Technical change to FieldPower®

PCN-number: PCN-PB40-PM11-20211015-00-A

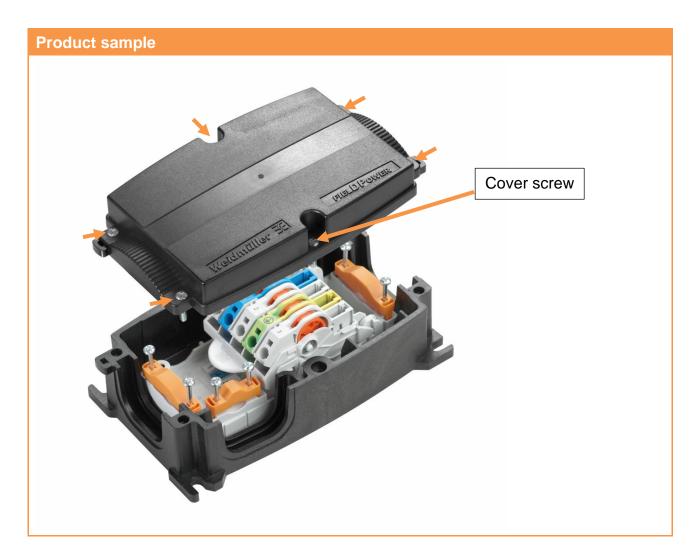
The screws for fastening the cover are changed in terms of drive and material.

Old: PZ2 - galvanized

New: TX20 - stainless steel V2A
